**A REQUEST FOR A CONCEPT PLAN REVIEW APPROVAL**  
**BY:** Peacock Properties LLC  
**FOR:** Mountain Legends Ranch Subdivision  
**WHERE:** NE of Driggs, along N. Stateline Rd.  
**PREPARED FOR:** Planning & Zoning Commission  
 Public Hearing of July 12, 2016

*Staff Report updated on 7-1-2016 (Key Issues, Considerations of Approval, Public Comments attached) & 7-5-2016 (Inter-Agency Comments, Public Comments attached)*

**REQUEST:** Peacock Property LLC is proposing a 76 lot subdivision on two parcels of land (approximately 197 acres) north of Driggs. The lots will be 2.5 acres, with approximately 100 acres in open space easements. These parcels are zoned A-2.5.

Figure 1: South parcel - Driveways that must meet local road standards or could be required to meet local road standards

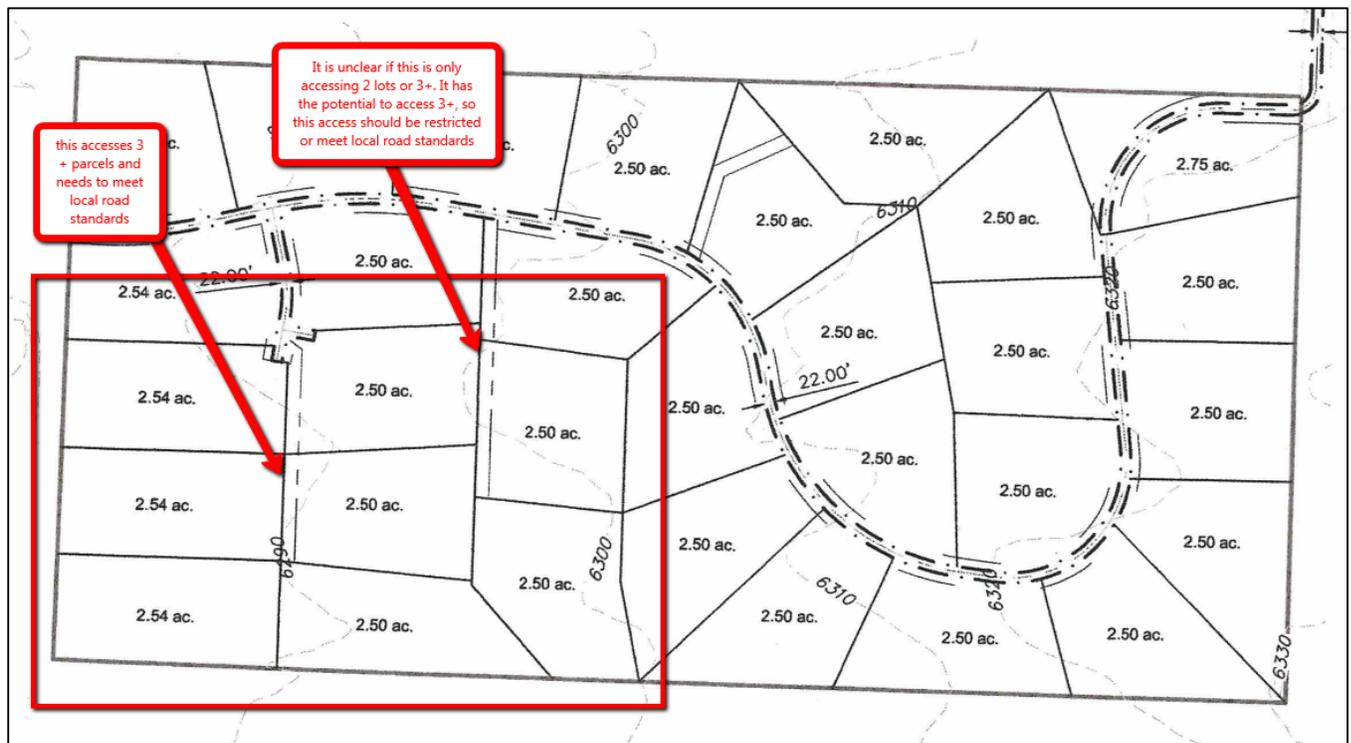
The Teton County Highway and Street Guidelines require that a driveway that accesses three or more parcels has to meet local road standards. Because of this requirement, the road must be extended, with the road surface area being removed from the lot areas. The parcels shown in Figure 1 below have the potential to access from different locations, so both should be designed as a local road, or a restriction should be added stating where the parcels are accessed from. However, at least one of the easements identified in Figure 1 has to meet local road standards because 3+ lots are being accessed.

1. Provide an updated plan with the public road right of ways of N. Stateline Road and N 1500 E removed from the lot areas, the addition to the subdivision road with the road surface removed from the lot area, and include an updated number of lots proposed for this subdivision.

Figure 2: North parcel - shared driveways

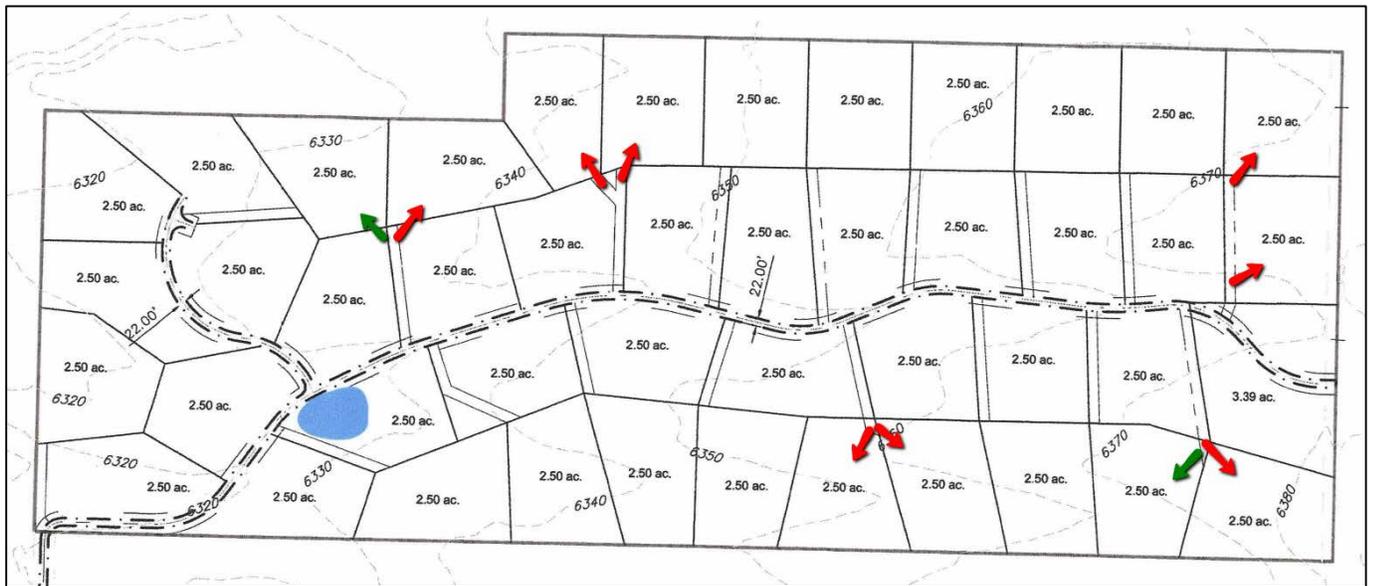
Assuming that every lot in the development that fronts the main subdivision road would access directly from the main road, there are 4 shared driveways that would require a unique street name for addressing purposes. One of these could be required to meet local road standards. There are two additional driveways that could provide access to two parcels, which would require a street name. Restrictions could be identified to only access one parcel, but because they are not, it is assumed they have can access two lots. This means there are 6 additional street names that would be required for this development. There is a seventh driveway easement that would access more than two parcels, but I did not include it, as I identified it above as needing to be a local road.

In Figures 2 and 3, the red arrows indicate parcels accessed by a driveway easement that would access at least two parcels. These would require a street name. The green arrows indicate a potential second parcel that could be accessed from the shown easement, which would then require a street name. The parcels with green arrows have another access option, so a restriction on the access location could clarify this and reduce the number of street names required. If the parcels that front the main subdivision road are not required to access from that road, the potential for more street names would increase significantly.
